CLOSURE

The Effects of Over-Compressing ASTM F959 Direct Tension Indicators on A325 Bolts Used in Shear Connections

Closure by Edwin R. Schmeckpeper

Fig. 1. (Revised) DTI Installation Methods

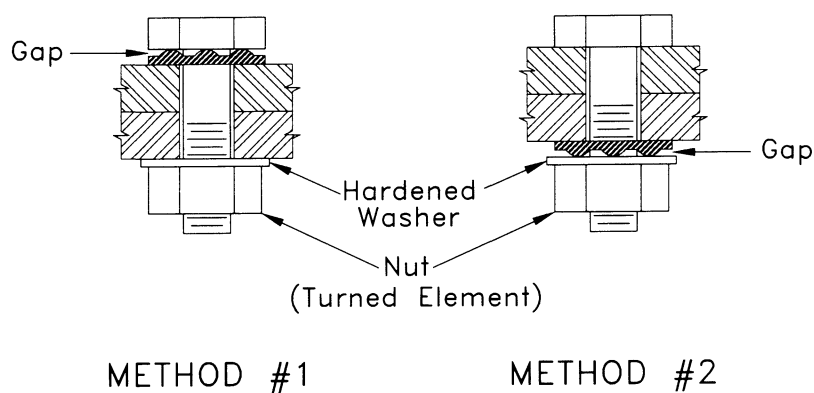
The comments concerning Figure 1 on page 40 of the subject paper are correct. There is a drafting error in Figure 1, for Method #2. The location of the DTI and hardened washer are transposed. The correct figure is given below.

It should be noted that the text of the paper which refers to Figure 1, on page 40, paragraph 2, places the DTI in the

correct location. The paper states “in Method No. 2, DTIs are placed under the ‘turned’ part”.
